Project	IEEE 802.16 Broadband Wireless Access Working Group < http://iee802.org/16 >	
Title	Proposed Revision to Section 8.3.5.13.1 (Alamouti Transmit Diversity Specification)	
Date Submitted	2001-11-05	
Source(s)	Brian Eidson Conexant Systems, Inc. 9868 Scranton Rd San Diego, CA 92121	Voice: (858) 713-4720 Fax: (858) 713-3555 [mailto: brian.eidson@conexant.com]
Re:	Proposal to revise Section 8.3.5.13.1 of document 80216ab-01_01r2 with provided text. This document is referred to by a comment made on 80216ab-01_01r2 by the Author.	
Abstract	Explanation of benefits of the revision, and full replacement text for this revision.	
Purpose	Incorporate provided text as revision of Section 8.3.5.13.1 of document 80216ab-01_01r2.	
Notice	This document has been prepared to assist IEEE 802.16. It is offered as a basis for discussion and is not binding on the contributing individual(s) or organization(s). The material in this document is subject to change in form and content after further study. The contributor(s) reserve(s) the right to add, amend or withdraw material contained herein.

Proposed Revision to Section 8.3.5.13.1 (Alamouti Transmit Diversity Specification)

Brian Eidson
Conexant S

Figure 1—Paired Blocks used for Alamouti transmit diversity

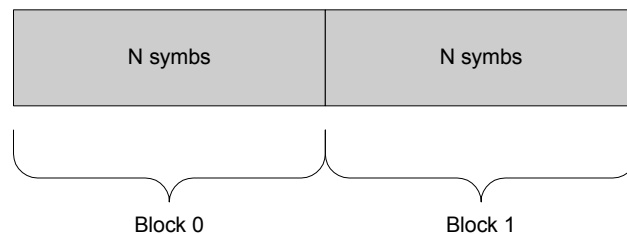
The Alamouti transmit diversity scheme multiplexes a pair of blocks over two antennas. In the previous description, a ‘delay spread guard’ was depicted between the paired blocks in Figure 169 of the original document). However, this obfuscates ensuing description; this guard is typically contained in either Block 0 or Block 1. The block structure of the analogous figure, Figure 1 (and its ensuing description), were modified to conform with the new descriptive format, where symbol elements between each transmit block are associated with one or the other transmit block.

Figure 1 illustrates the concept of block pairing used by a Alamouti transmit diversity scheme. A two-antenna transmitter system must format data into such logically paired blocks to obtain the promised diversity.

Figure 2—Cyclic Prefix-based Alamouti framing

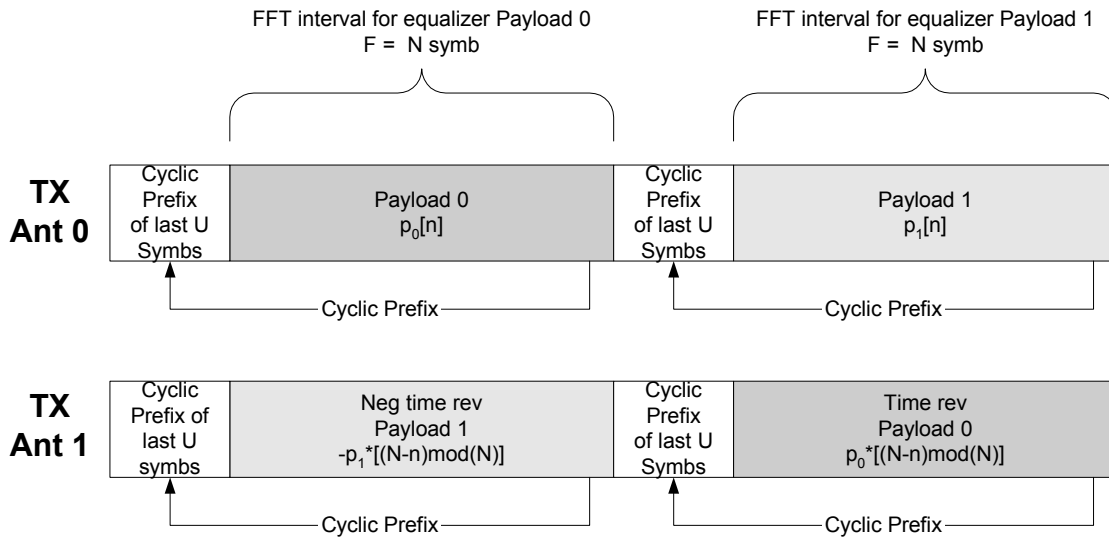
Framing structures were also modified. Figure 170 was eliminated as unnecessary. Figure 171 (Figure 2 in amendment proposal) was generalized to illustrate the use of a cyclic prefix to form Alamouti blocks. These cyclic prefixes were assumed to be derived from arbitrary data, which could contain a Unique Word. In 80216ab-01_01r2, Figure 171 was derived from a Unique Word. To capture this application, Figure 3 in the amendment proposal illustrates how a Unique Word would be used as a cyclic prefix. Appropriate text descriptions were also added to accompany these figures.

Figure 2 illustrates the baseline framing structure for Alamouti transmit multiplexing. This is a cyclic-prefix-based frame structure, with cyclic prefix repetitions chosen to facilitate efficient FFT-based processing at the receiver. Observe that the payload portions of Figure 2 reflect the Alamouti antenna multiplexing format described in Table 1 Transmit Antennas 0 and 1. Note that pilot symbols may be inserted within Payloads 0 and 1 to facilitate the use of frequency domain equalizers with time-domain decision feedback taps.

Figure 4—Alamouti Frame Preamble and/or Pilot Structure using UWs

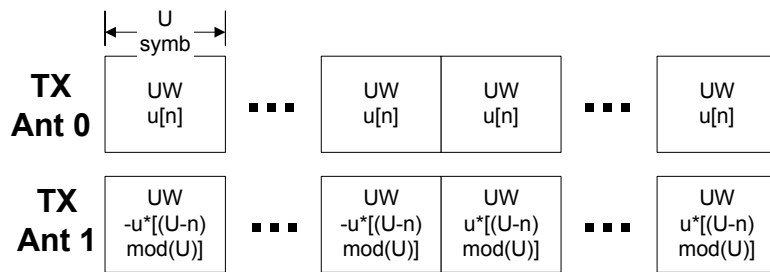
Since both burst and continuous transmission systems contain frame preambles, a description and illustration of a preamble format for Alamouti transmit diversity systems was added. This preamble is composed of Unique Words, formatted using Alamouti transmit diversity multiplexing. This preamble is completely consistent with scalar (non-Alamouti) frame preambles, which are also composed of Unique Words. It was also duly noted that this preamble format could also be used as a pilot symbol format that is incorporated into the transmit stream.

Figure 4 illustrates a structure that shall be used as a burst frame preamble or a continuous frame preamble for a Alamouti transmit diversity system. Note that, like a continuous frame preamble, this structure may also be inserted within a transmission (of burst or continuous format) as group of contiguous pilot symbols, to assist in channel estimation and updating within a burst. In such an instance, this contiguous pilot symbol structure is considered external to the paired Alamouti payload data blocks illustrated in Figure 2, although the pilots may appear after every K-th paired payload block, where K is an integer greater than or equal to 1.
